水務署
Water Supplies Department

**Approval of “DURBAN” Sensor Flush Valve
(General Acceptance No. ZC20260584F)**

Name of Manufacturer: TOTO (Guangzhou) Co Ltd
Country of Origin: Chinese Mainland
Brand: Durban
Details of Fitting: 25mm Sensor flush valve for WC
Model: DRN-S1122
Body Markings: **TOTO**
Expiry Date: 16 August 2031

DRN-S1122

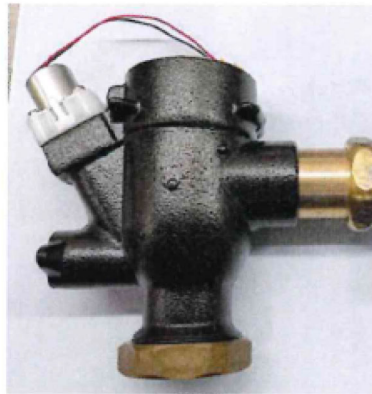
As the fitting has not been tested for use in contact with water intended for human consumption, the fitting can only be used in flushing water plumbing systems.

"Installation of filter before flushing valve is required. Without the filter, the flushing valve is liable to leak. The installed filter need frequent inspection and cleaning to maintain flushing supply. Normally only public toilets with good management system for maintenance would be considered."

"A stop cock or gate valve must be installed at the upstream of the fitting for manual isolation of water supply."

"The design flushing volume of the flushing valve should be compatible with the toilet bowl to ensure that effective clearance can be achieved by a single flush of water."

"Flushing valve should be used within the range of working pressures specified by the manufacturer." AND

"Installation of electronic opening and closing sanitary tapware should also comply with the requirements of Electrical & Mechanical Services Department."
